VEHICLE SAFETY DEFECT SERVICE BULLETIN

Recall Campaign 05V291000 US Units

Re: Safety Recall- Air Brake Line Reversed

RECALL 05V291000/CANADA 05-212 TREADLE/ATC VALVE PLUMBING

Figure 1

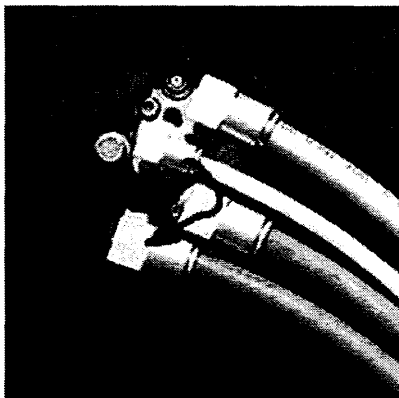
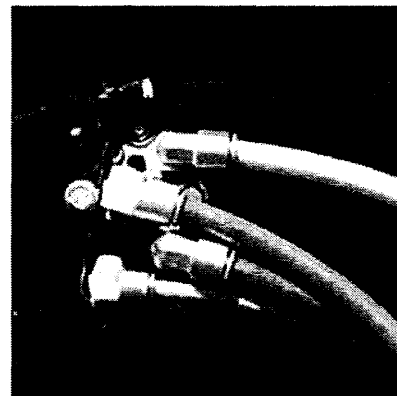
1. Set the parking brake, chock the wheels and release pressure from the air tanks and lines.
2. Locate the Brake Pedal/Treadle Valve Assembly on the outside of the firewall.
 - A. Remove the 5/8" Red delivery line and 3/8" Green delivery line by pushing in on the collar of the brass fitting while pulling out on the air line (see figure 3). DO NOT cut the lines.
 - B. Reverse the brass fittings using an approved thread sealant. (See figures 1 and 2).

***Incorrect brake pedal/treadle valve plumbing
(Located on front of dash/firewall)***

Corrected brake pedal/treadle valve plumbing

Figure 3

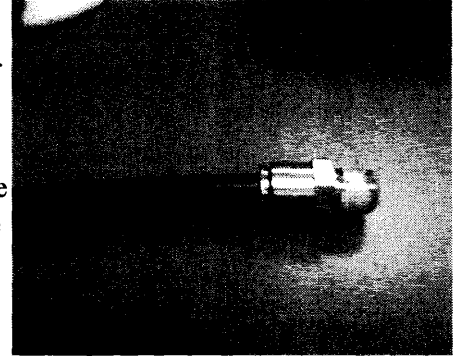
Removal of air line from fitting

1. Set the parking brake, chock the wheels and release pressure from the air tanks and lines.
2. Locate the brake Pedal/Treadle Valve Assembly on the outside of the firewall.
 - A. Remove the 5/8" Red delivery line and 3/8" Green delivery line located on the bottom of the treadle valve, by pushing in on the collar of the brass fitting while pulling out on the air line (see figure 3). DO NOT cut the lines.
 - B. Reverse the brass fittings on the bottom of the treadle valve using an approved thread sealant. (See figure 4.)
 - C. Reinstall the air lines in to the fittings by pushing the airline in firmly; pull back lightly to insure the line is locked into the fitting.

Figure 4

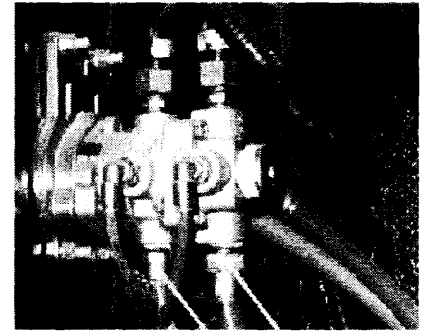
Delivery lines to be reversed

1. Locate the inversion valve under the coach at the rear axle.
 - A. Swap the 3/8" red line to the delivery side of the rear ATC valve (next to the 3/8" orange line) with the 3/8" red line that runs to the front brake quick release valve (front exit off of T-connection) as shown in figure 5.

Figure 5

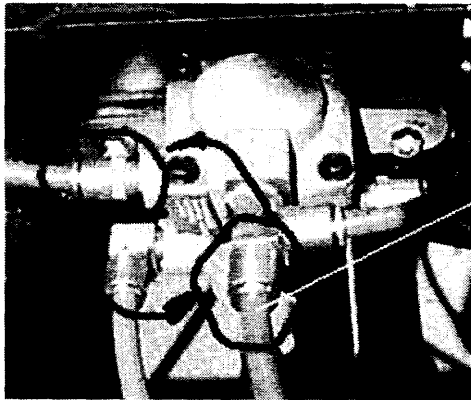
Cheetahs will need approx. 8" added to this air line.

- B. Push in on the collar of the fitting to release the air line and pull out.
- C. Fittings do not need to be swapped on this valve.
- D. Cheetahs **ONLY** will need approximately 8" of air line added to reach the side of the inversion valve, using the splice included in the parts kit.
- E. Reinstall air lines into the correct fittings and pull lightly to insure that they are seated in the fitting.
